Promote Wildlife Conservation and Responsible Nature Based Tourism for Sustainable Development in Vietnam

Review CEO Endorsement and Make a recommendation

10787

Hannah Fairbank

FIGURE 3: THEORY OF CHANGE DIAGRAM

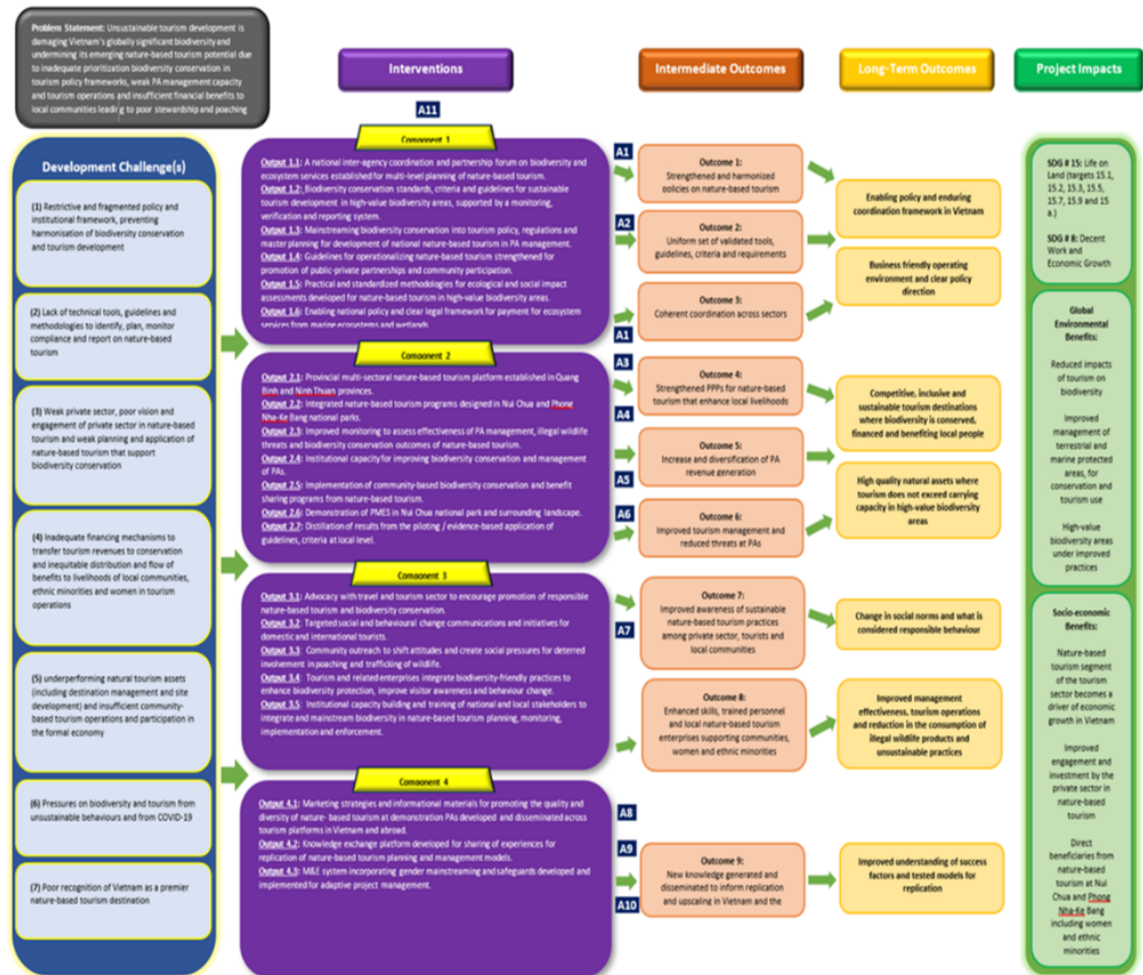
- 1.) Figure 3 ToC Diagram is not attached in the CER. And the figure/table numbers referred in the text (both referring CER text and prodoc) does not match or cannot find in the document ? please correct/include.
- 2.) Please include component texts in the TOC (from Prodoc). In fact, all figures in CER document are unavailable. Please correct.
- 3.) We couldn't find Annex H ? changes to the project design during the PPG phase. Note the CER includes some more additional activities (2.7, 3.5), which is relevant to add. Please correct.
- 4.) Not clear which activities will contribute to core indicator 4.1? Please address.

1) Per the screenshot below, Figure 3 TOC is present in the CER. References to Figure 3 in the CER and corresponding figure and table in the ProDoc have been updated accordingly to match. A final check was made to ensure all references to figures and tables in both the CER
